Construction Division
Additions & Alteration Charges Approval Form

Company Name:	Modi Properties Pvt Ltd	Site	May Flower Platinum
Name of the customer	Lanka Yamaja		
Villa/ Flat No.	A-508		
Sl.No	Description	Amount	
1	Total extra Charges	7480=00	
2	Total refundable amount	12,454=00	
3	Net amount to be charges (if any)	—	
4	Net amount to be refunded (if any)	4,974=00	
Remarks :			
Approved by Project Manager		Approved by Design Team	
Date 01/02/2022		Date	
Sign: 		Sign:

Details of Additions & Alterations

Flat No	508	Block no.	'A' ✓
Flat Area	1800 sft	Type	Deluxe / Luxury
Buyer Name	Lanka Vanaja		
Phone No.	9291467225/8977701484/9704184572	Email	Prakashgandrakota@gmail.com

WORKING DRAWING OF FLAT.NO.A-8

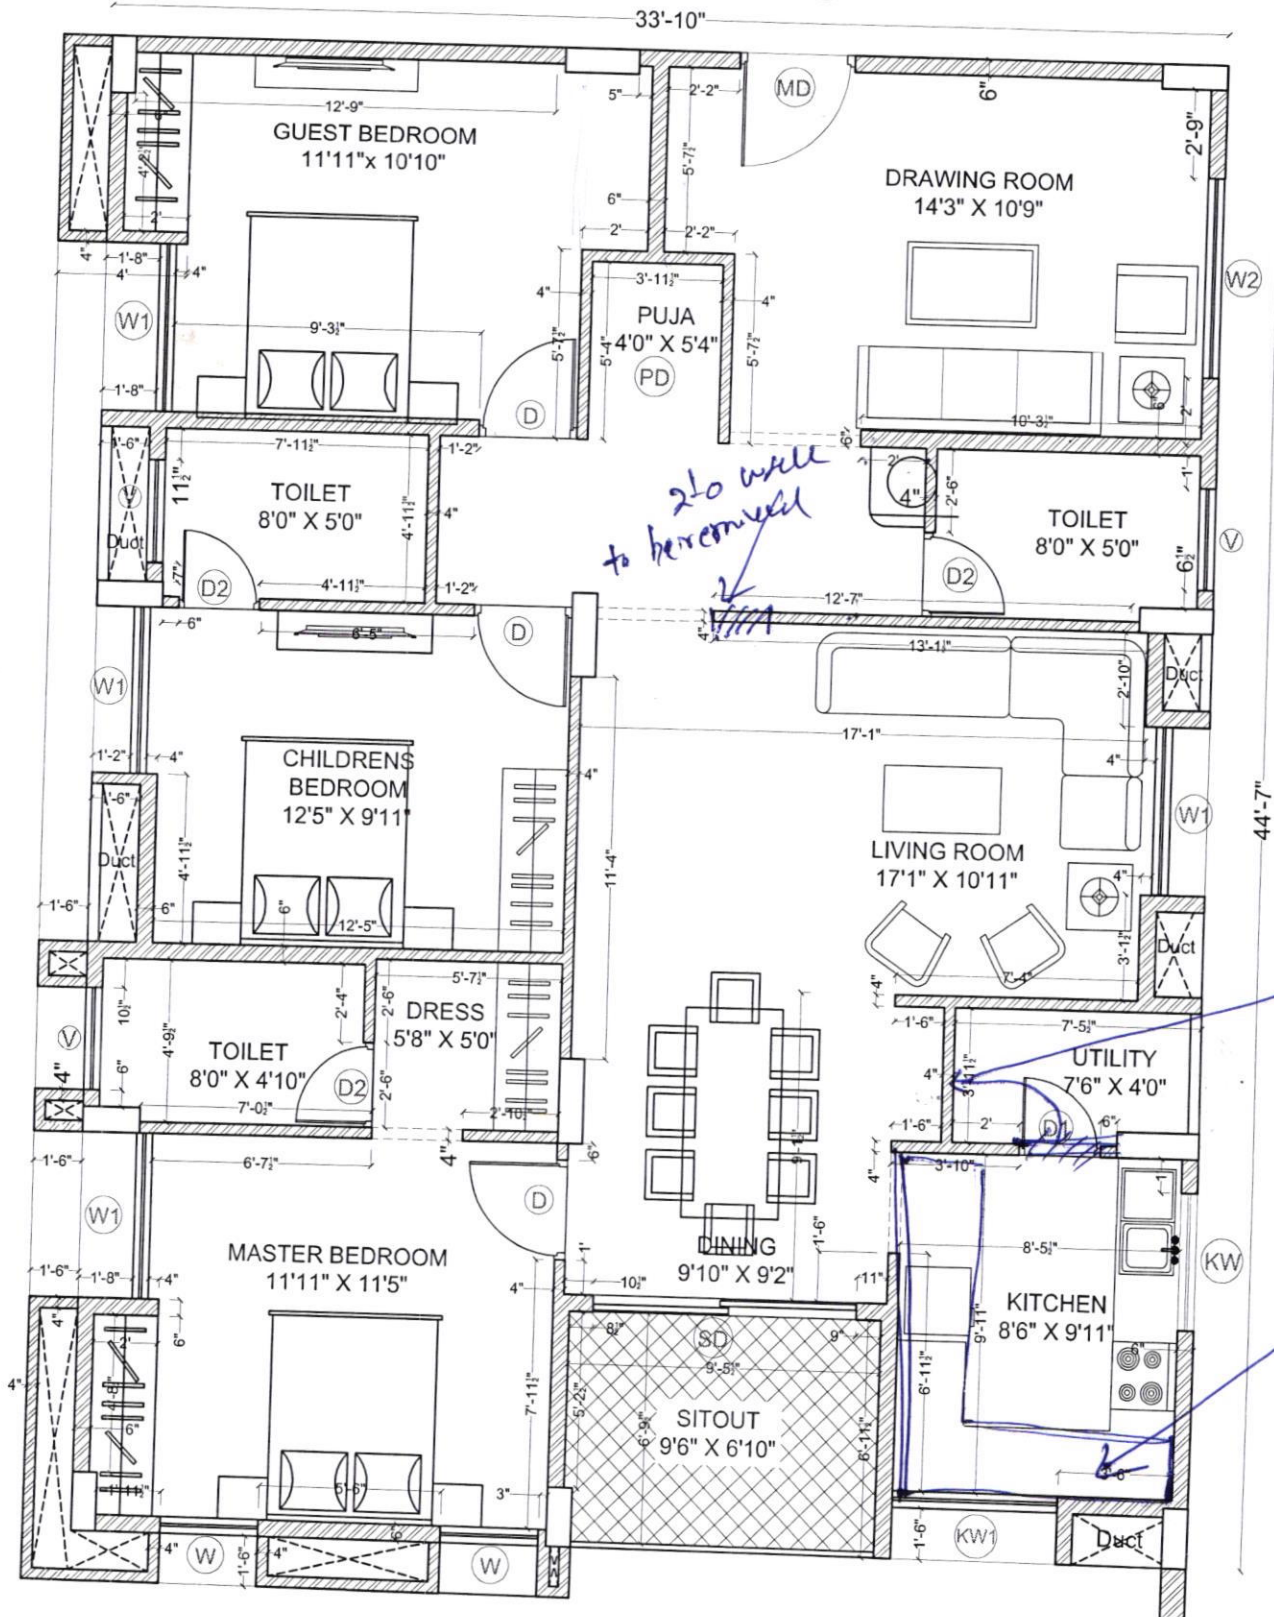
- ① Left extension required (marked on plan, Rec platform)
- ② modular Kitchen with granite top it should be 32" from FFL

- Other Changes:
- ① Hooker to be provided at Sit out area.
 - Imp ② utility door to be shifted (marked on plan)
 - ③ 26 wall of living to be removed (marked on plan)
 - ④ Balcony railing SS with glass required.
 - ⑤ all windows 3 - pane with mesh. (ok)

ELECTRICAL PLAN OF FLAT-A8

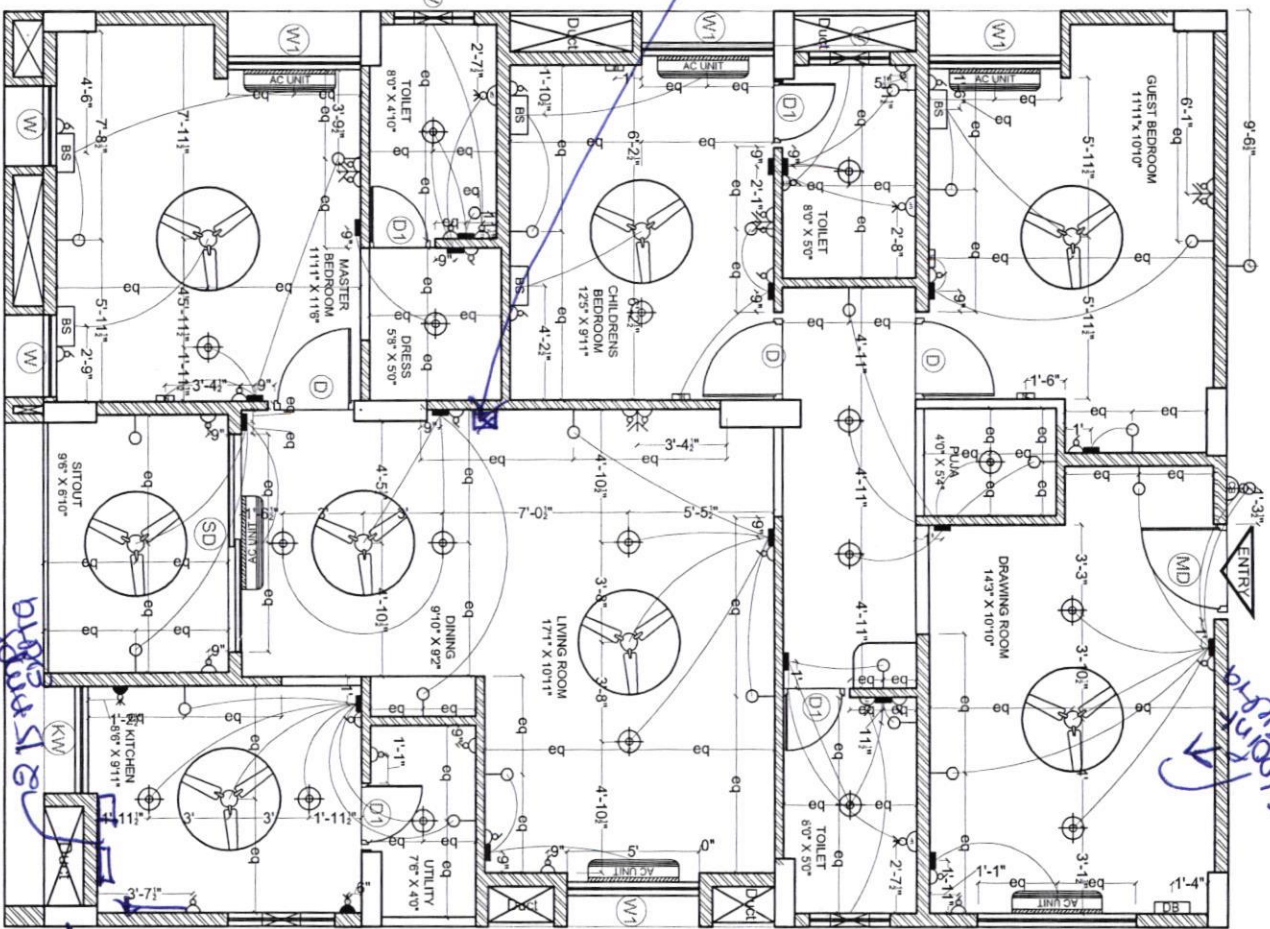
- ① 15 amp extra pt in dining area (marked on plan)
- ② AC outlets to be given in all 3 bedrooms (customer will tell ht)
- 3) 3 Bedrooms & Dining hall internet cable.
- 4) ② 15 Amps points extra at kitchen
- ⑤ Shifting point lobby point marked on plan
- 5) 3 Bedroom & ward wiring

Description		Direction	Owners & Developers :		Date :	Promoted by	
PLUMBING PLAN OF A8		N	Modi Properties Pvt. Ltd.	Prepared By :	09.01.2020	Modi Properties &	
			Project Name & Phase :	Approved By :		Investments Pvt. Ltd.	
			Mayflower Platinum	Scale :		Phone:+91-40-66335551

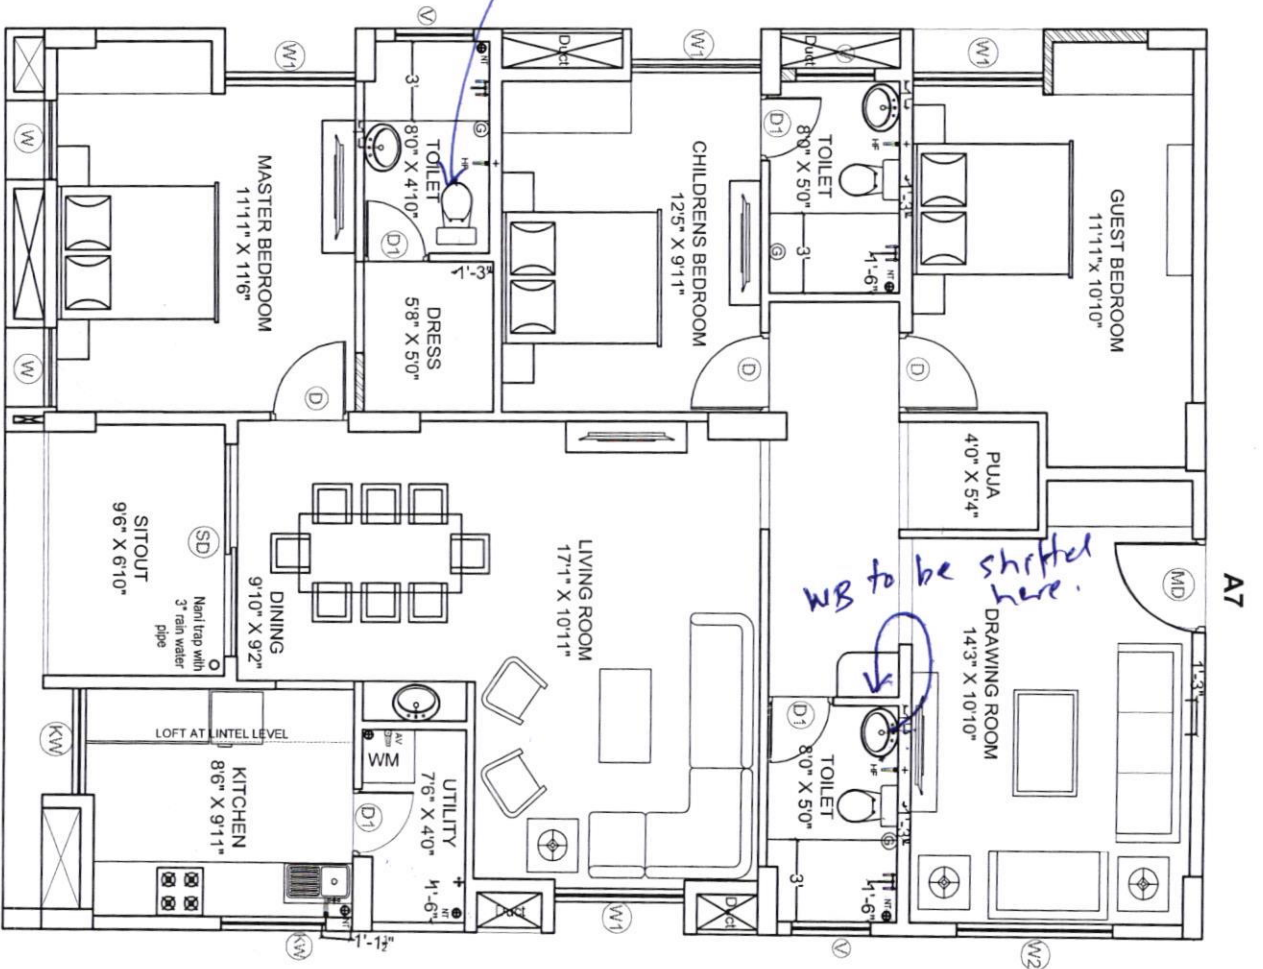
- ① WB to be shifted at common toilet marked on plan.
- ② EWC in MBR to be shifted to south facing than existing west facing.
- ③ MBR and CBR - customer will buy Anglo-Indian WC for two toilets.
- ④ Bathroom tiles same as A-106 (model floor)

EWC to be shifted to south facing.

WB to be shifted here.
